AS-BUILT CREW PRINT		<small>ALL REQUIRED GROUND RODS HAVE BEEN DRIVEN & VERIFIED TO BE WITHIN FPL STANDARDS. VALUES ARE SHOWN AT ALL LOCATIONS.</small>		<small>JOB CERTIFIED COMPLETED AS SHOWN ON THIS AS-BUILT PRINT. MATERIAL CHANGES SHOWN IN RED.</small>		AS-BUILT COPY	
FOREMAN'S SIGNATURE _____ DATE _____		FOREMAN'S SIGNATURE _____ DATE _____		SUPERVISOR'S SIGNATURE _____ DATE _____		INITIALS _____ CERT. DATE _____	
Easement?	Yes <input type="checkbox"/> No <input checked="" type="checkbox"/>	Survey/Stake?	Yes <input type="checkbox"/> No <input checked="" type="checkbox"/>	Work with SMO?	Yes <input type="checkbox"/> No <input checked="" type="checkbox"/>	FPL FDOT – City of Pahokee Install 50 New Lights v/o SR 15/US 441 (from S of Shirley Dr to Main St), Pahokee, FL 33476	
Tree Work?	Yes <input type="checkbox"/> No <input checked="" type="checkbox"/>	Designer/Stake?	Yes <input type="checkbox"/> No <input checked="" type="checkbox"/>	CT/Special Mtr?	Yes <input type="checkbox"/> No <input checked="" type="checkbox"/>

FDOT - City of Pahokee
 Install 50 New Lights
 v/o SR 15/US 441 (from S of Shirley Dr to Main St), Pahokee, FL 33476
 Designed by: Jessica Builes Date: 02/20/23
 Drawn

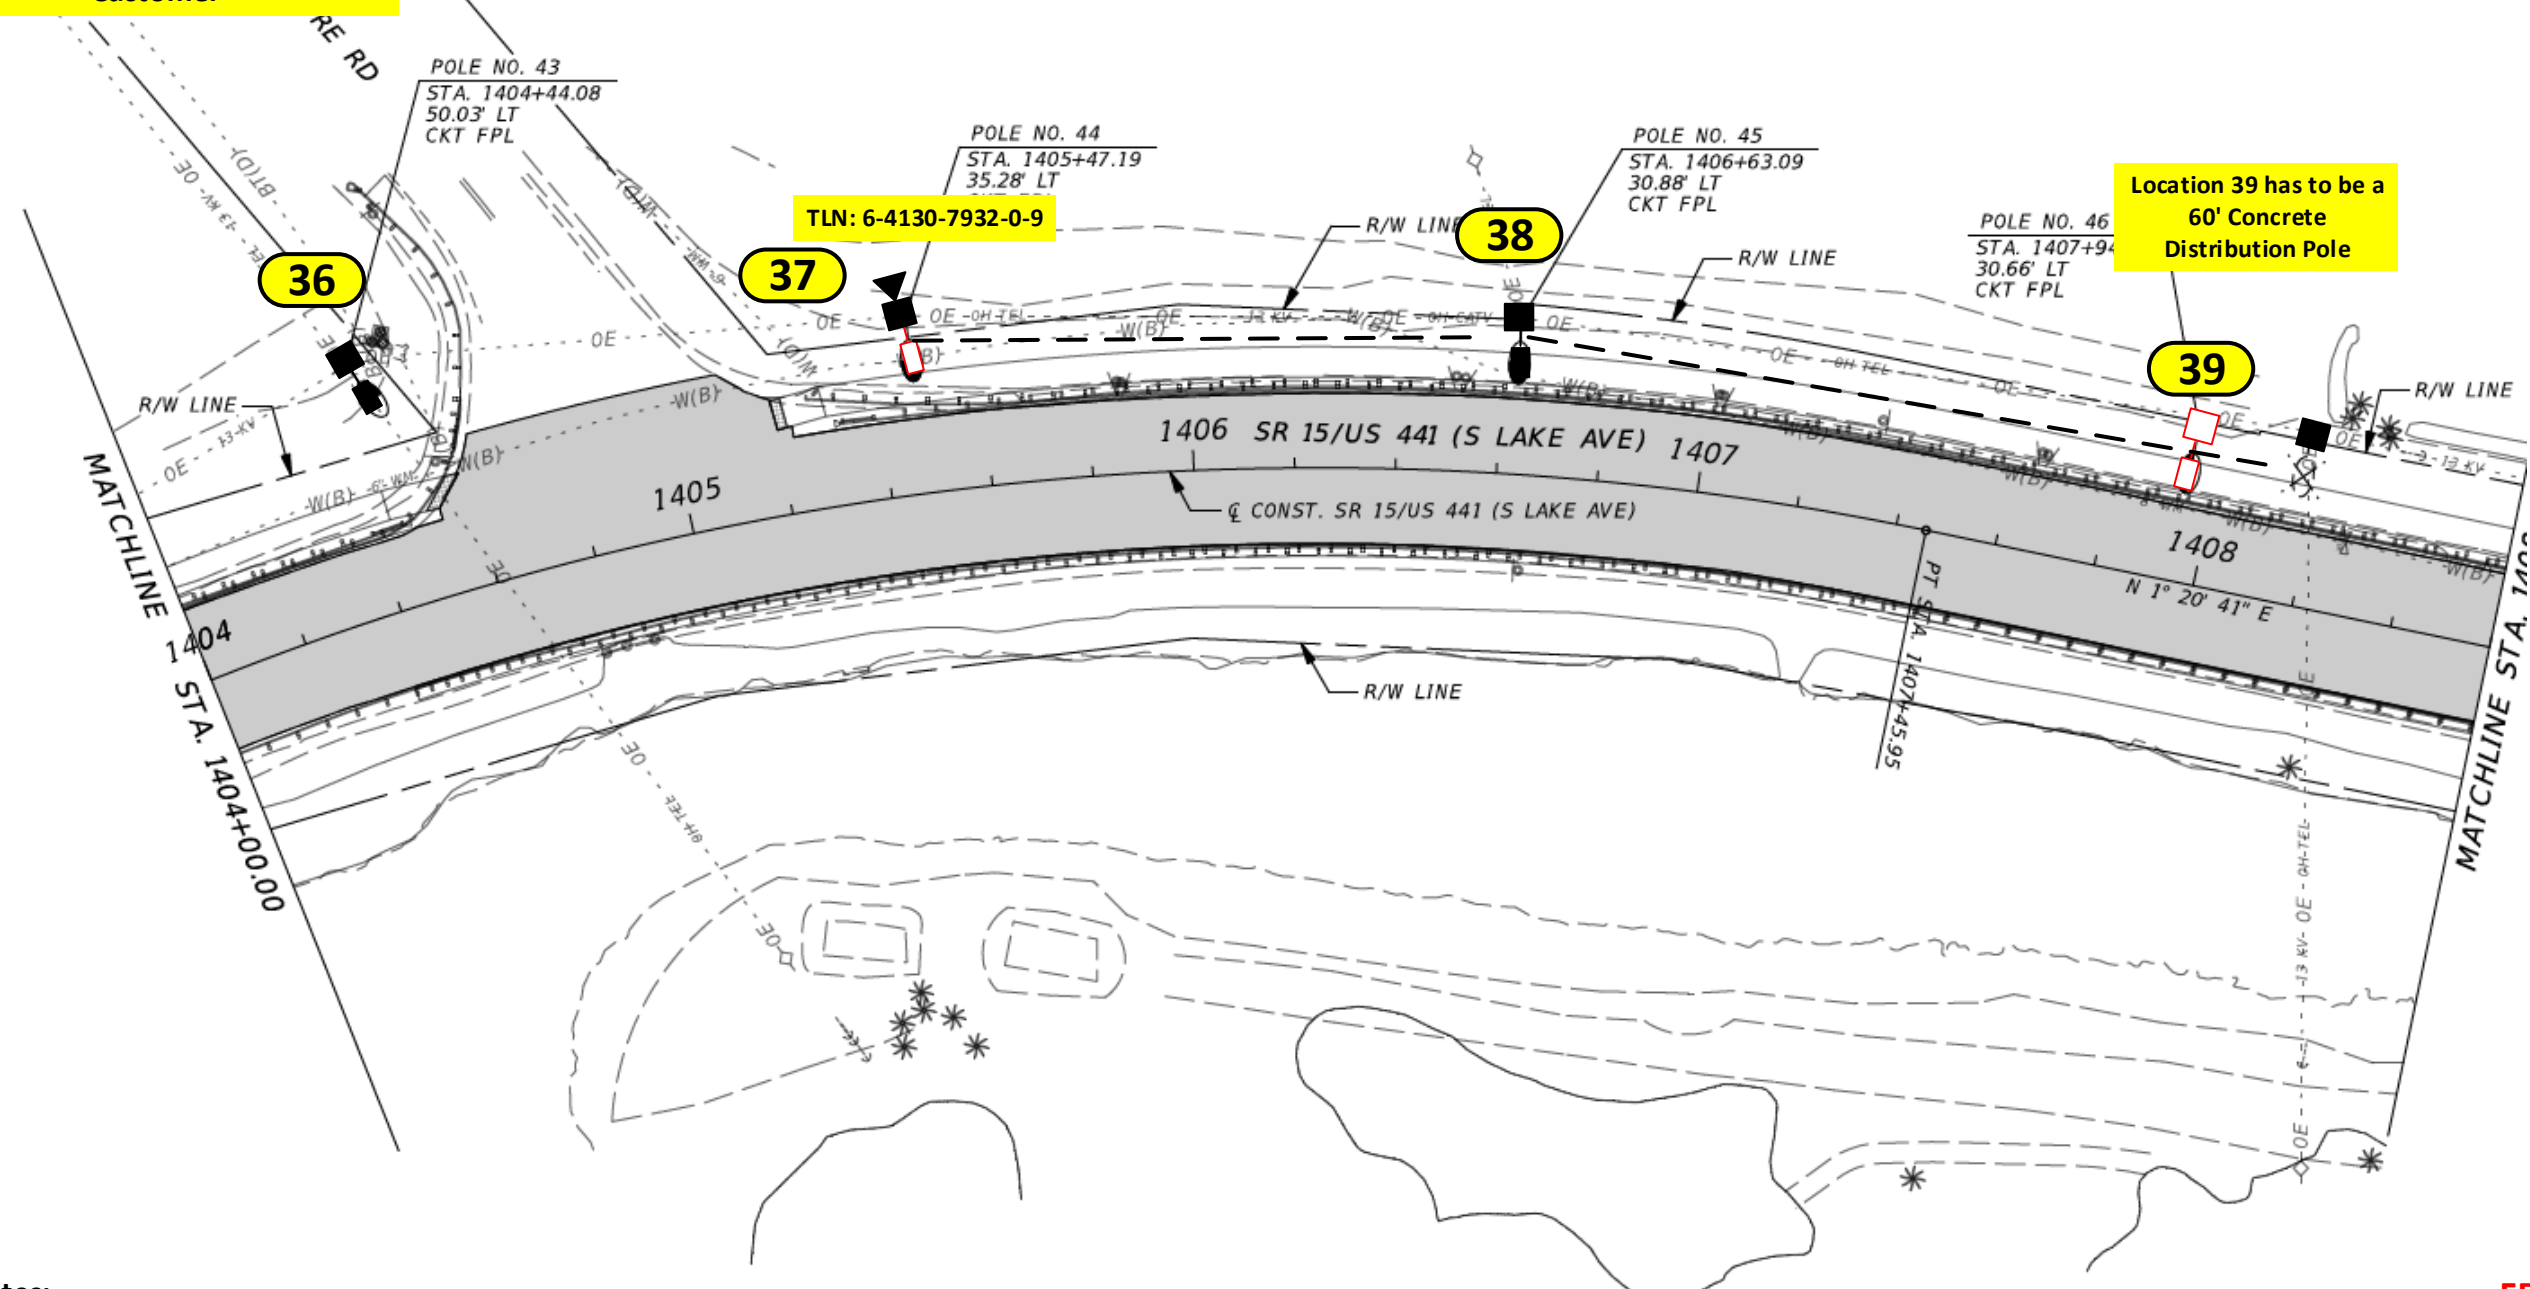
Mounting Height on Distribution Pole cannot be determined by the Customer

Location 39 has to be a 60' Concrete Distribution Pole

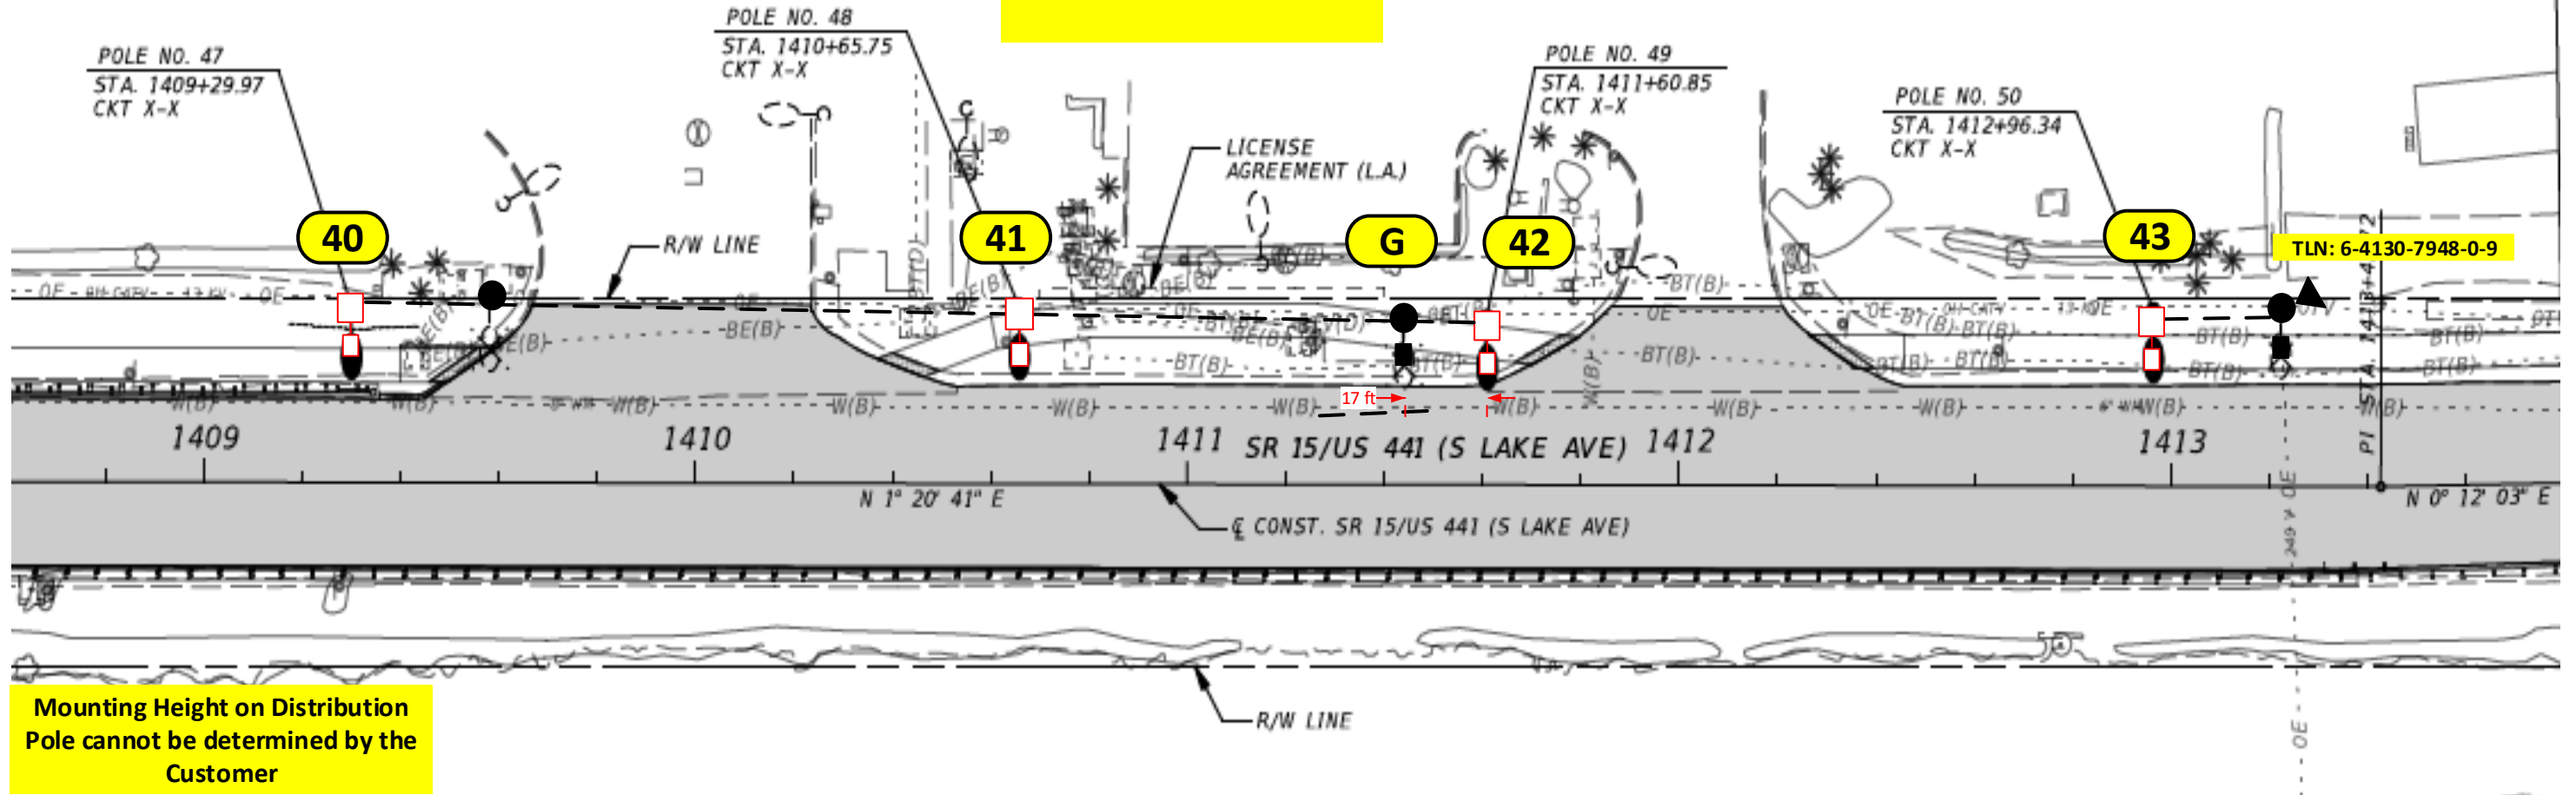
Loc. 38, 39, 40 and 41 have to be Distribution Concrete Pole

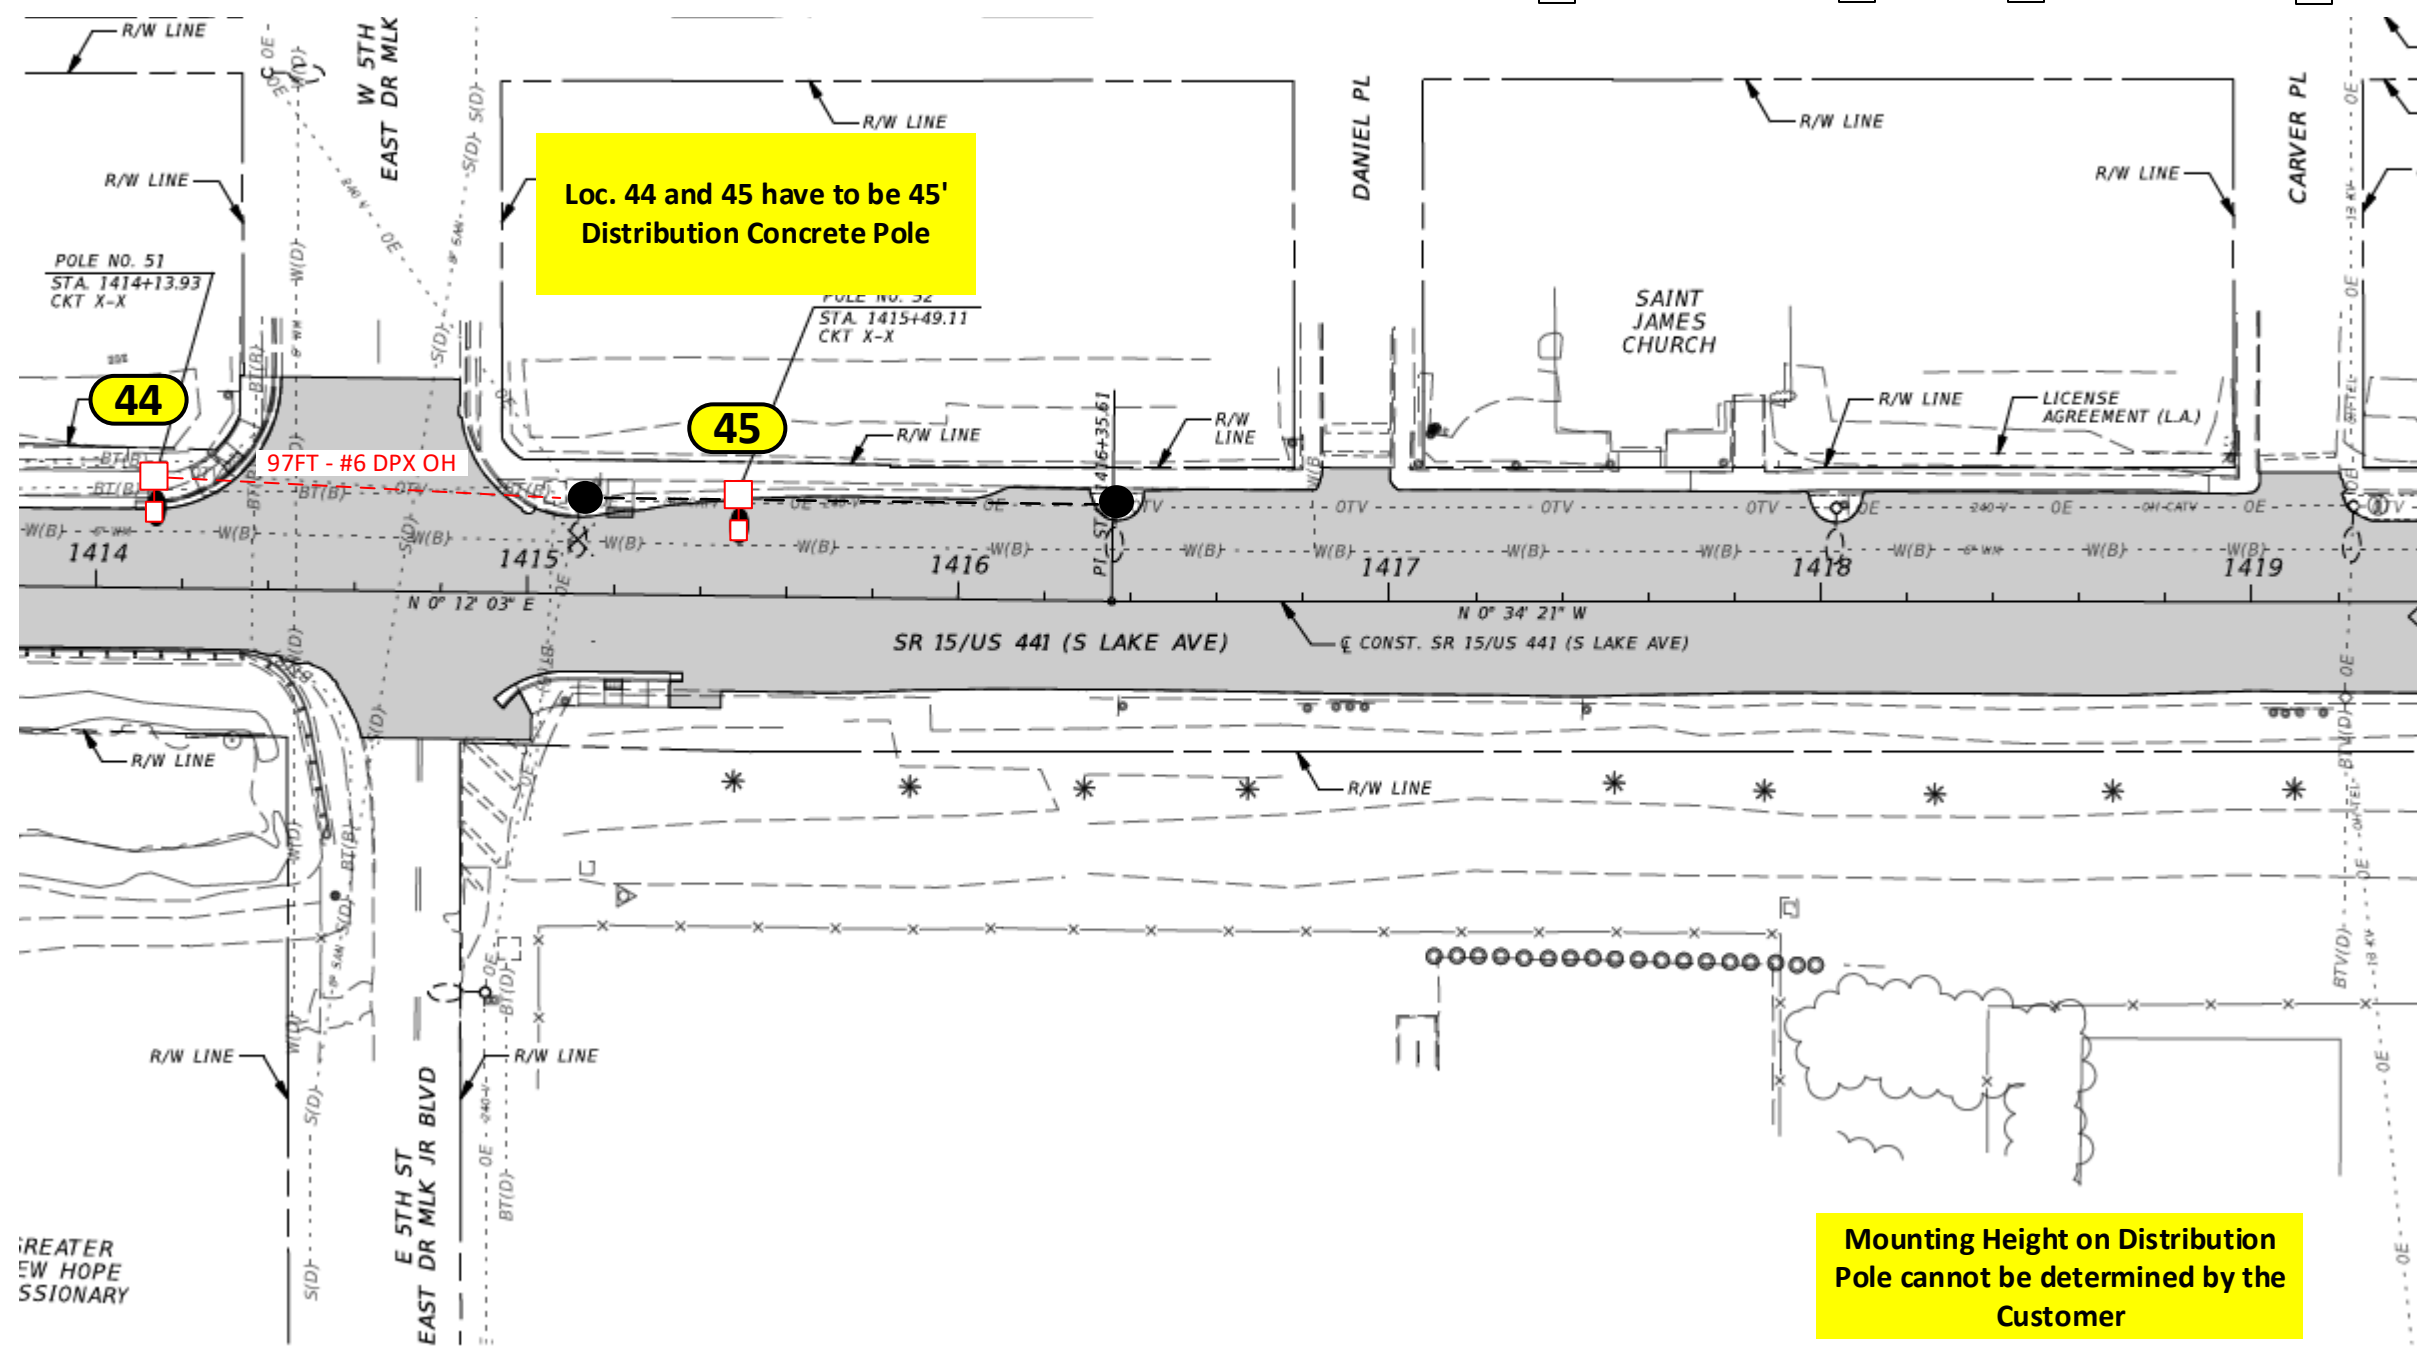
Mounting Height on Distribution Pole cannot be determined by the Customer
